# REGIONAL REVIEW NOTIFICATION

**ARC REVIEW CODE:** R2105261

**Name of Proposal:** Project Granite DRI #3298

**PROJECT GRANITE DRI**  
**City of Atlanta**  
**Natural Resources Group Review Comments**  
**May 25, 2021**

GSWCC CERT. (LEVEL II)	0000057727
DRAWN BY	KHA
DESIGNED BY	KHA
REVIEWED BY	JCR
DATE	03/26/2021
PROJECT NO.	015170056
TITLE	DRI SITE PLAN
SHEET NUMBER	C0-20

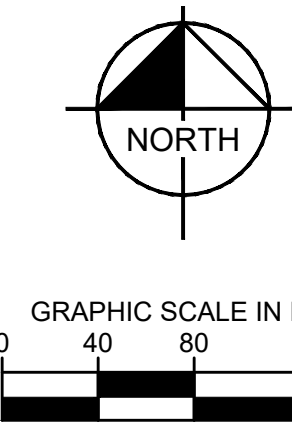
To capitalize on this long-term potential, care should be taken to ensure that the development, as constructed, promotes an interconnected, functional, clearly marked and comfortable pedestrian experience on all streets, paths, entrances, and parking areas. During the pre-review/methodology meeting on April 26, 2021, questions were raised about east-west pedestrian access across the site and where BeltLine access would be provided. These options are now more clearly identified on the submitted site plan, with a pedestrian plaza marked under the northeastern multifamily building and sidewalks shown on the street at the southern edge of the site, with a ramp leading down to the trail. The northern access point, if not fully ADA-accessible, should also contain a bike channel to allow for easier access.

The eastern boundary of the site is a former rail corridor that is now one of the two potential trail/transit alignments for the BeltLine. Regardless of the ultimate path of transit, the trail portion on this eastern segment should be completed at the earliest opportunity to provide a connection between the new Westside BeltLine Connector Trail and Jefferson Street to the south up to West Marietta Street and the DRI site to the north. This will address a major gap in the pedestrian and bicycle network in this area, in conjunction with planned bicycle facilities on West Marietta Street. Another issue raised by both the City Department of Transportation and the Upper Westside Community Improvement District is the potential for redesigning the intersection of Herndon Street and West Marietta Street to be more pedestrian oriented. It's currently designed with a slip lane for tractor-trailers serving the previous industrial use, but this should be filled in to reduce vehicle speeds when turning and shorten the pedestrian crossing distance.

There were no bicycle improvements proposed.
